# Halton Hills PREMIER GATEWAY PHASE 1B SECONDARY PLAN STUDY

Public Open House Summary Report

July 2016

Preliminary Land Use Concept - Option 1.

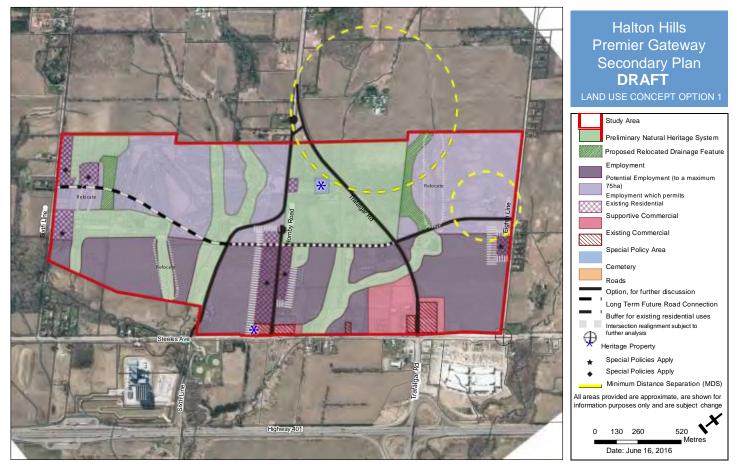
<u>Part A:</u> Options 1 and 2 illustrate schematic locations for a proposed east-west collector road with two different access locations onto Sixth Line. Participants were asked to indicate which option they preferred, and why.

- Table 3 indicated a preference to locate the proposed east-west collector road immediately north of the study area, in order to mitigate disruptions to existing residential clusters.

- Table 4 indicated a preference to remove the east-west collector road in order to mitigate the potential for vehicle congestion along Sixth Line. An observation was made that the collector road could be replaced with a series of cul-de-sacs, which would be accessed via Steeles Avenue, and that this is a common occurrence within employment areas in surrounding jurisdictions.

- Table 5 indicated a preference for the east-west collector road alignment which is illustrated in Option 1.
- Table 6 indicated a preference to remove the east-west collector road in favour of providing an east-west service road, to be located immediately north of Highway 401. An observation was made that similar solutions have been implemented along the QEW throughout the Greater Toronto Area and Greater Golden Horseshoe. This could be augmented by an east-west collector road, located immediately north of the study area.

- Table 7 indicated concern over the alignment of the east-west collector road, and the impact it would have on existing residential clusters. An observation was made that property values would be impacted, and that resulting expropriation or easements could fragment properties, and would place existing dwellings too close to the proposed road.
- Some participants expressed concern over the prospect of the proposed east-west collector road splitting Hornby Road.

<u>Part B:</u> Option 2 shows an alternative intersection at Eighth Line and Steeles Avenue. Participants were asked which option they preferred, and why.

• Tables 2 and 4 preferred Option 2, which would facilitate the re-alignment of Eighth Line around the existing cemetery.

<u>Part C:</u> Options 1 and 2 illustrate a cul-de-sac on Hornby Road at the north end of the existing residential cluster in order to discourage truck traffic. Participants were asked whether they agreed that Hornby Road should have a cul-de-sac, or whether it should remain open.

• Table 5 indicated a concern that the proposed cul-de-sac condition may not prevent trucks from using Hornby Road, even if appropriate signage is provided to prevent them from doing so.

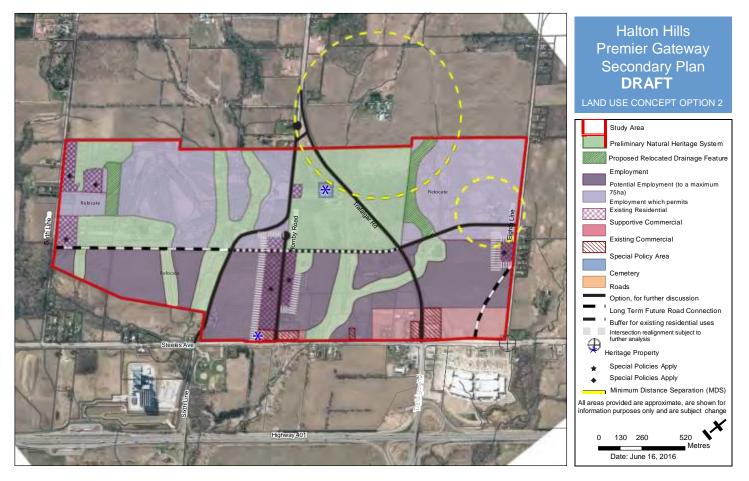
- Table 6 indicated that the proposed cul-de-sac should be located south of the proposed eastwest collector road, in order to mitigate potential noise and traffic impacts on existing residential clusters. However, an observation was made that this configuration would not address existing residential clusters located north of the proposed east-west collector road.
- Table 7 indicated a preference for the proposed cul-de-sac along Hornby Road.
- Several participants, who reside in a cluster of properties which comprise the centre and northern end of Hornby Road, wish to stay within their homes, but expressed concerns about

potential noise and traffic impacts. An observation was made that the alignment of the proposed north-south collector road could be altered. This would shift the right-of-way further west, away from existing residential clusters along Hornby Road. The proposed cul-de-sac condition, along Hornby Road, could then be extended further north, closer to Trafalgar Road, in order to service additional residential dwellings. In this scenario, buffer treatments should be extended further north along Hornby Road.
